STAFF RECOMMENDATION

1124 Sharpe Avenue

December 16, 2020

Application: Demolition; New Construction—Infill

Figure 1. 1124 Sharpe Ave.

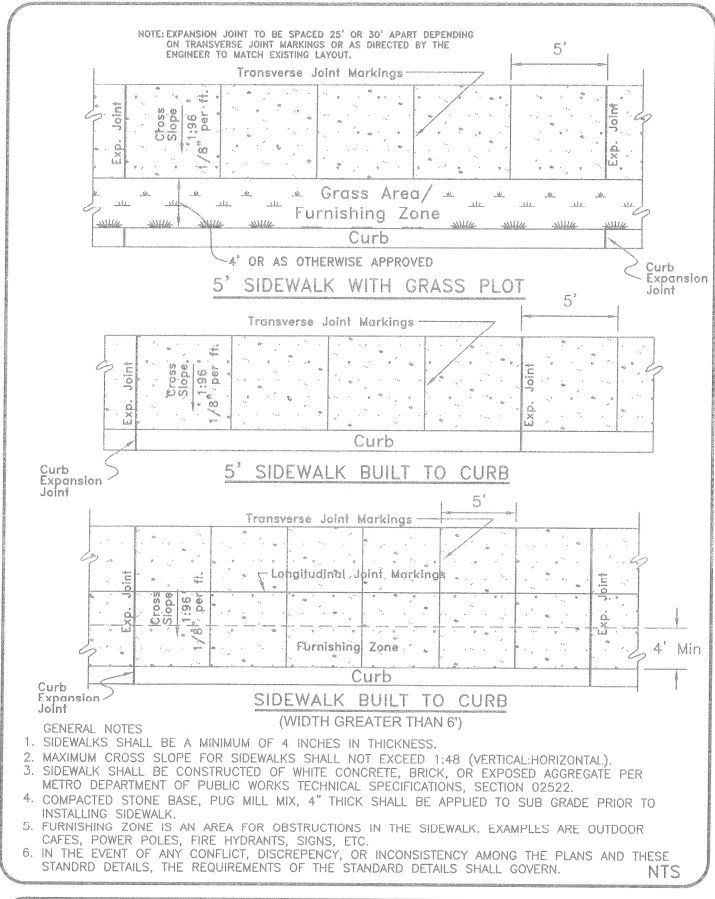
Background: The house located at Sharpe Avenue was constructed c. 1996 and does not contribute to the historic character of the Eastwood Neighborhood Conservation Zoning Overlay (Figure 1). Most of this block of Sharpe Avenue was included in the 2014 expansion of the overlay.

Demolition: The house at 1124 Sharpe Avenue was constructed c. 1996. In addition to its later date of construction, its form, detailing, and deep front setback do not match the historic context of neighborhood (Figure 1). Staff, therefore, finds that the structure does not contribute to the architectural and historical character and significance of the district, and that its demolition meets Section III.B.2 for appropriate demolition and does not meet section III.B.1 for inappropriate demolition.

PLOT PLAN FOR:
AMERICAN HOMES, LLC
1124 SHARPE AVENUE
NASHVILLE, TN 37206
MAP 83-01, PARCEL 355
INST # 20200619-0065634
DATE: NOVEMBER 25, 2020

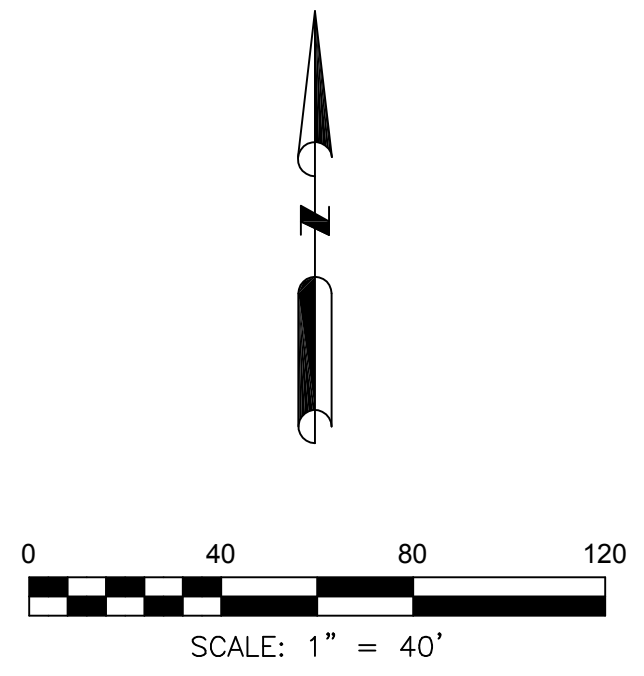
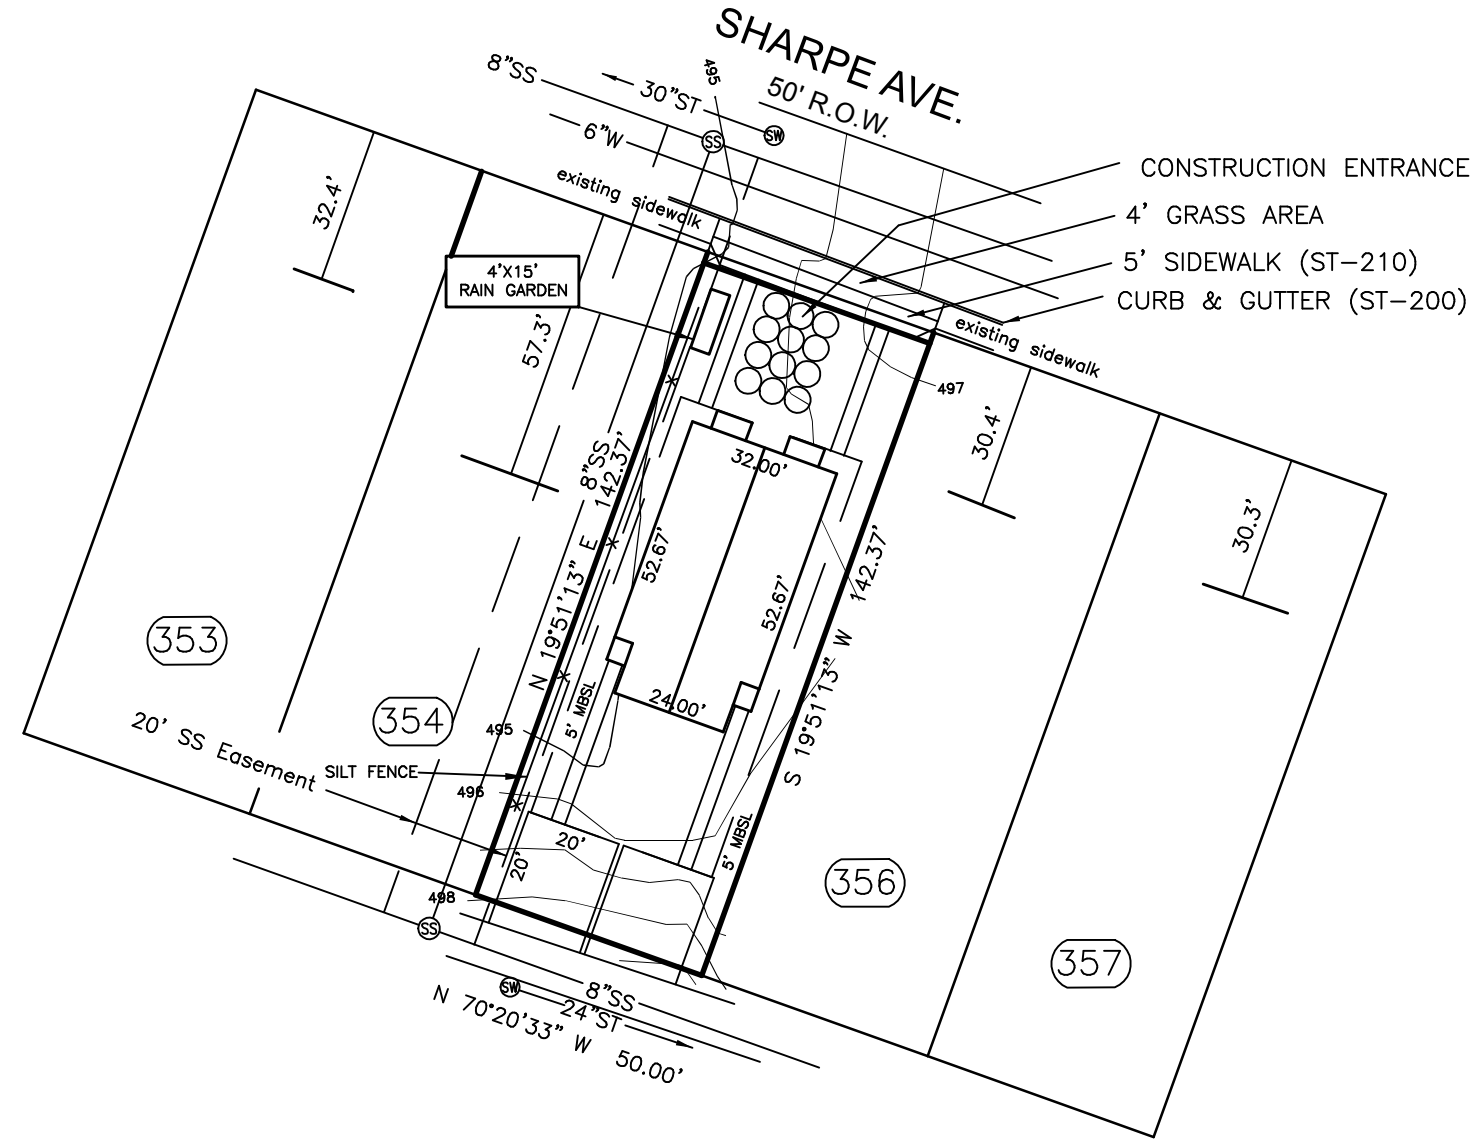
Setback & Rhythm of Spacing: The front setback is approximately thirty feet, four inches (30'- 4") which is appropriate as it is similar to the historic house at 1126 Sharpe Avenue. The infill is located approximately nine feet (9') from the right-side property line, ten feet (10') from the left, and forty-nine feet (49') from the rear property line. The project meets all base zoning setbacks and the setback and rhythm of spacing are appropriate for the historic context.

1. The finished floor height shall be consistent with the finished floor heights of the adjacent historic houses, to be verified by MHZC staff in the field;
2. The front setback should be consistent with the buildings to either side, to be verified by MHZC staff in the field;
3. Staff shall approve all materials prior to purchase and installation;
4. Siding shall be smooth face and have a maximum reveal of five inches (5"); and
5. The HVAC shall be located behind the house or on either side, beyond the mid-point of the house.

FRONT ELEVATION

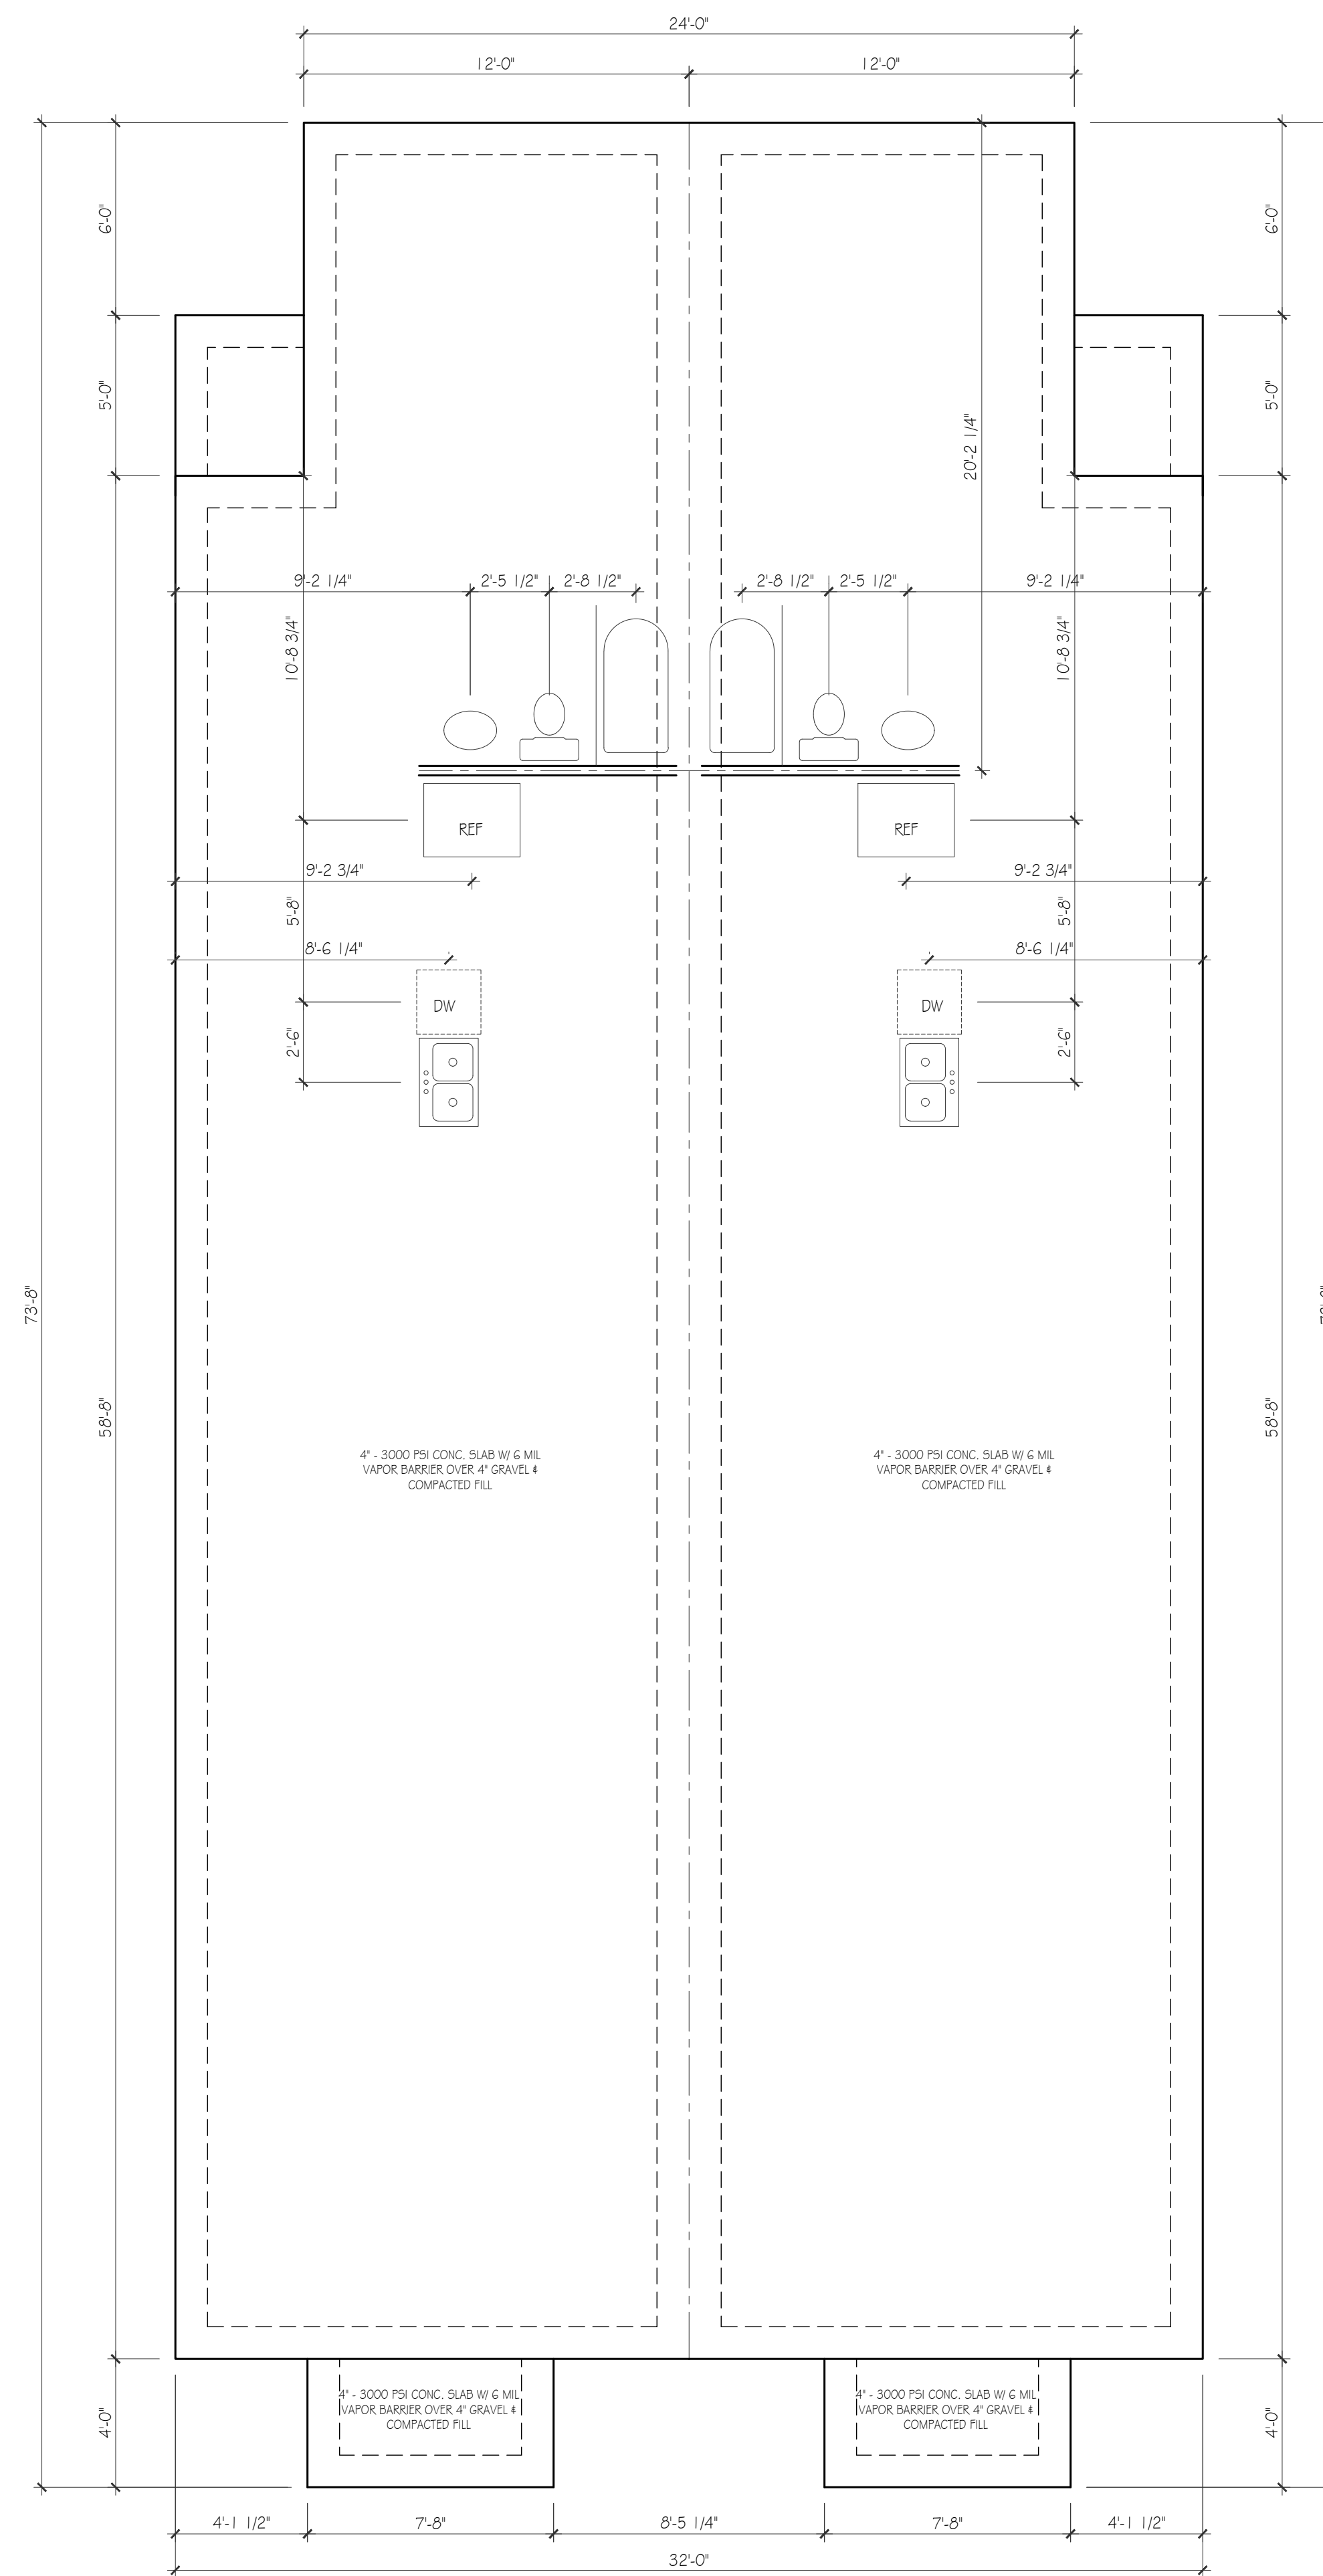
Height & Scale: The 1100 block of Sharpe Avenue has a strong historic context of one-story and modest one and one-half story historic homes. As proposed, the infill is a modest one and one-half story home that is appropriately scaled for the historic context. The overall height is approximately twenty-four feet, eleven inches (24'-11") from grade, and the eaves at the front are ten feet (10') from grade. The infill is thirty-two feet (32') wide, which is also appropriate for the context as historic homes range from approximately twenty-five to thirty-three feet (25' – 33') wide on this block.

The applicant has indicated that the infill will be clad in smooth Hardie siding with a five inch (5") reveal with smooth Hardie trim and a split-face CMU foundation. The details of the other materials are not indicated. Staff recommends review of all materials. With these conditions, the project can meet Section II.B.1.d of the design guidelines.

Roof form: The infill is side gabled with a primary pitch of 6/12. The plan incorporates two shed dormers with 4/12 pitches on the front and gabled hoods with 6/12 pitch that cover each front stoop. The rear includes rear gabled elements that read as a dormer and single-story rear addition.

The project does not meet Section II.B.1.e.

Proportion and Rhythm of Openings: Most of the windows on the infill are all generally twice as tall as they are wide, thereby meeting the historic proportions of openings. Each side façade includes two smaller horizontally oriented windows located on the lower level near the rear of the house. Given the location and minimal visibility, staff finds that this could be appropriate. There are no large expanses of wall space without a window or door opening.
